Belvac Production Machinery Technical Bulletin

ISSUE 2, VOLUME 13, MARCH 2010

NECKER SYSTEMS ROTARY UNION REPLACEMENT

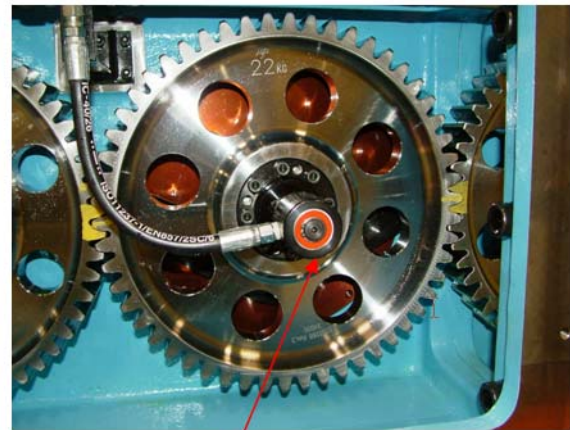
Belvac has used Duff-Norton brand rotary union (part number C48517) for many years on Autolube Necking systems. Due to quality issues with this unit that could not be resolved, Belvac partnered with Rotary Systems Inc. to develop a unique and robust rotary union specific to Belvac's application. A carbon steel construction with hardened shaft, dual seal ball bearings, and Teflon seals make the new rotary union distinctive and durable. The new rotary union is assigned a new Belvac part number C10179 that is directly interchangeable with the Duff-Norton unit for ease of maintenance and replacement in the field.

All new Belvac Autolube turrets, such as the Neckers, the Flangers, the Reformers/Re-profilers, and the Light Testers will use the new Rotary Systems union C10179 starting May 1st 2010. After this date, Belvac will no longer supply the Duff-Norton union C48517 on any of its equipments and will be automatically substituted with C10179. Should you have any questions, please contact our Service department at the numbers shown below and our friendly staff will be glad to help.

Discontinued Duff-Norton
Rotary Union: C48517

New Rotary Systems
Rotary Union: C10179
